Form C-103
Revised July 18, 2013

WELL API NO. 30-015-28938	
5. Indicate Type of Lease STATE <input checked="" type="checkbox"/> FEE <input type="checkbox"/>	
6. State Oil & Gas Lease No.	
7. Lease Name or Unit Agreement Name OXY SPIKE	
8. Well Number 1	
9. OGRID Number 160825	
10. Pool name or Wildcat FRONTIER HILLS; STRAWN (GAS)	
11. Elevation (Show whether DR, RKB, RT, GR, etc.)	
12. Check Appropriate Box to Indicate Nature of Notice, Report or Other Data

BC OPERATING, INC. RESPECTFULLY REQUESTS APPROVAL TO RE-CEMENT THE OXY SPIKE #1 A SECOND TIME BECAUSE THE 1ST SQUEEZE FAILED TO BRING CEMENT UP INTO THE 8-5/8" INTERMEDIATE.
SEE ATTACHED PROCEDURE AND WELLBORE DIAGRAMS

Second squeeze procedure

After 1st Squeeze Job

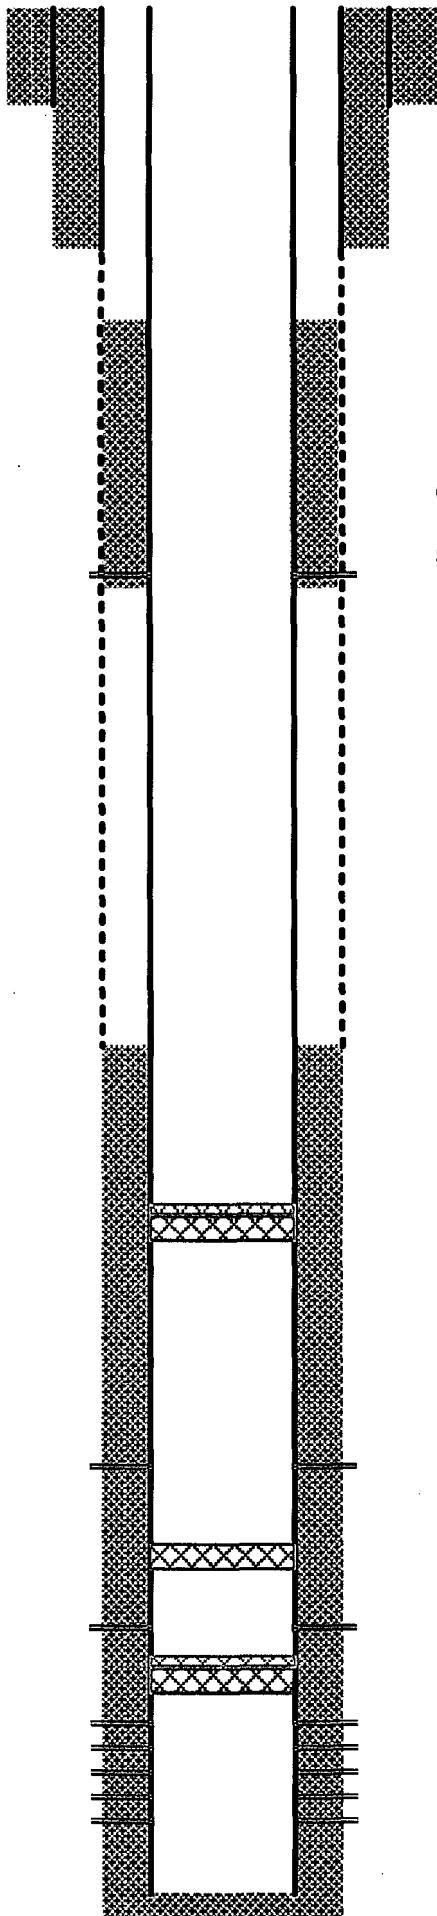
The initial cement squeeze failed to bring cement up into the 8 5/8" intermediate. The top of cement came up to 3,480' with the 8 5/8" casing shoe at 3,050'.

- GIH w/ perforating gun and shoot 4 squeeze holes at 3,450'.
- Rig down CH wireline unit.
- Establish injection rate into squeeze perforations.
 - Open casing valves to 5 1/2" x 8 5/8" annulus.
 - Establish circulation to surface
 - Establish injection rate into perforations.
- Recement 5 1/2" casing to surface as follows:
 - Mix and pump 300 sacks of 65/35 Class C/Pozmix containing 6% Gel.
 - Mix and pump 200 sacks of Class "C" neat cement.
 - 834 ft³ calculated
 - Calculate volume of cement circulated to surface.
 - Determine final pump rates and pressures.
- Shut well in 24 hours
- Pick up 4 5/8" bit.
- Drillout cement retainer and cement.
 - Test squeeze to 500 psi.
